E7515A-07B-S

Safety Service Note

E7515A UXM Wireless Test Set

POSSIBLE ELECTRIC SHOCK HAZARD

PSM Metal Bracket Clearance issue

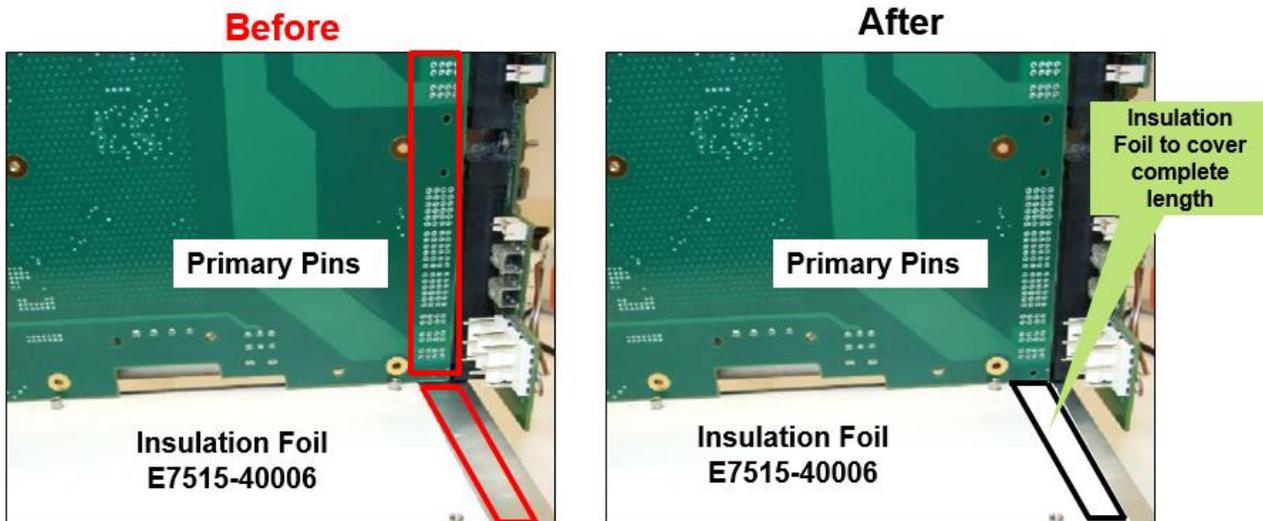
Power Supply Module (PSM) has insufficient insulation between mains circuits and ground.

Keysight identified that the E7515A has insufficient insulation between mains circuits and ground, resulting in non-compliance with the internationally recognized IEC 61010-1 safety standard. In the event of a fault condition, this may represent an electric shock hazard to users. There have been no reported incidents of this hazard to date.

PSM Insulator sheet issue

All the existing E7515-61812 PSM assemblies in the customer installed base, and the internal assets, will be replaced when the instrument is returned to Keysight for service.

Priority will be given to utilize part number E7515-69828, however, if there is no availability, part number E7515-61828 is also a valid part number.
